Docket Item # 3 & 4 BAR CASE # 2016-00233 & 2016-00234

BAR Meeting July 27, 2016

**ISSUE:** Permit to Move, Remove, Encapsulate or Demolish and Certificate of

**LOCATION:** 530 North Columbus Street

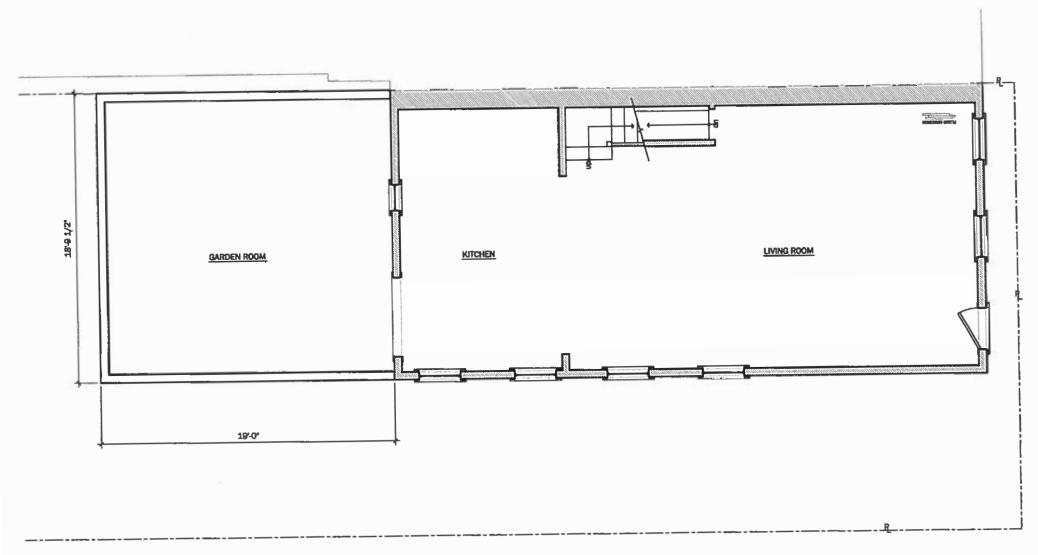
I'm currently writing the staff report about your proposed project at 530 N. Columbus, and I find your application is missing some key details. Firstly, in the *description of proposed work section*, you write that you wish to "replace windows" -- which ones, how many, and with what?

Sorry for the omissions. I would like to replace all 13 existing 6 over 6 windows with new 2 over 2 windows. The existing windows are not original and are not appropriate to the style/era of the house. The replacement windows will be wood, double hung, double pane w/ simulated TDL muntins.

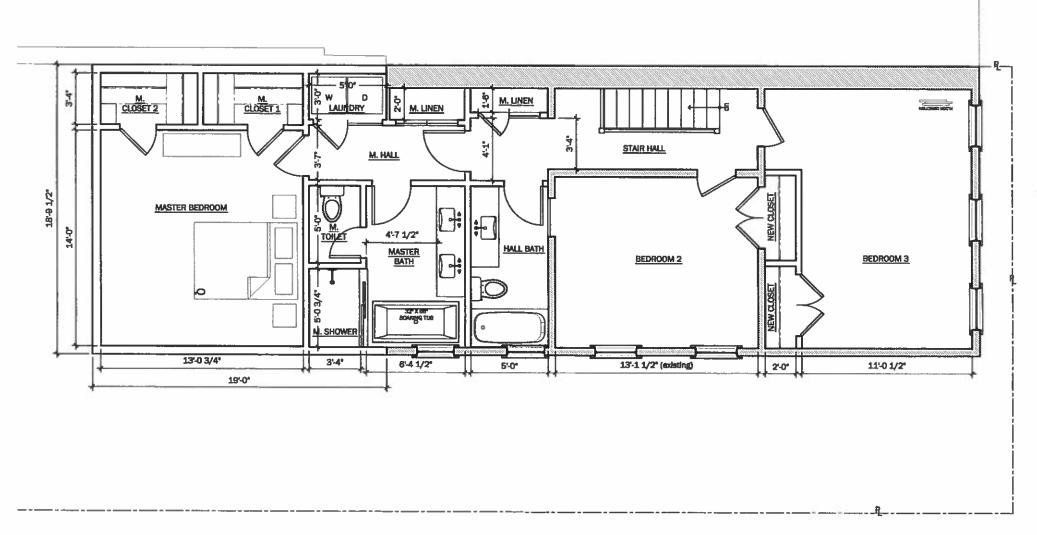
Secondly, in regards to the addition, you don't state either in the application or on the submitted drawings what colors or materials you plan to use and you don't include any specs for the windows or doors. The image below is from the *Additions & New Construction* section of the application:

The windows & doors of the addition will be wood; the windows will be casements w/ simulated TDL muntins. The columns are fiberglass, and the panels beneath the windows are wood frame with an inset fibercement panel. The color of the addition is Benjamin Moore China White, the shutters are Black Forrest Green.
